BECHTEL	**Mechanical Handling Data Sheet** Top Running, Double Girder	CM 3	Data Sheet No. 24590-HLW-M0D-HPH-00064 Plant Item No. 24590-HLW-MJ-HPH-CRN-00001 Rev. 3

Project	RPP-WTP	Description	Canister Handling Crane (Lower)
Project No.	24590	Supporting Calculation No.	N/A 3
Planning Area		Associated Drawing No.	N/A
System No.	HPH	Associated Specification No.	24590-WTP-3PS-MJKG-T0003
Building No.	30	Associated MR No.	24590-QL-MRA-MJKG-00002
Quality Level	▶ CM 3		
Seismic Criteria	SC-II		
Function	Canister Handling and Maintenance Activities

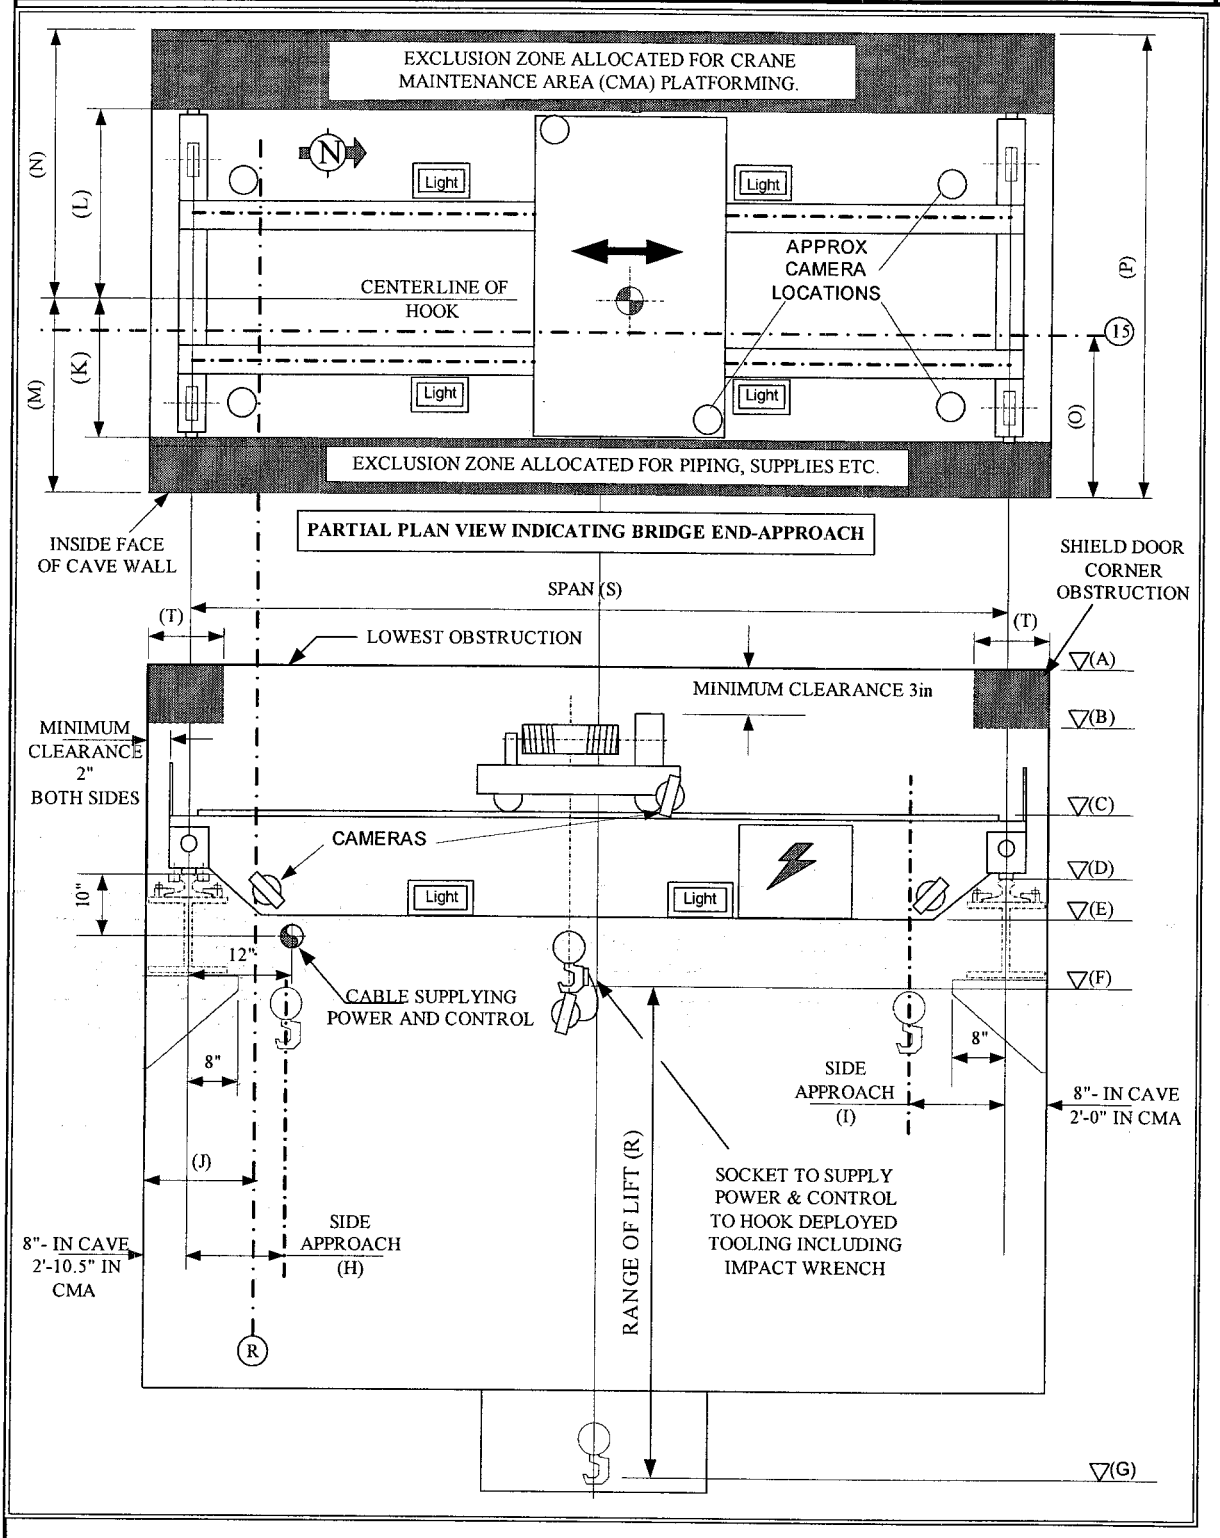
► 13. Revision 3 changes: Safety Classification changed to APC; Quality Level changed to CM; Calc ref deleted; Dimension K & M ammended to include bumper extensions that allow bumpers to engage on cave wall, IAW 24590-HLW-ACA-M-05-00031 3
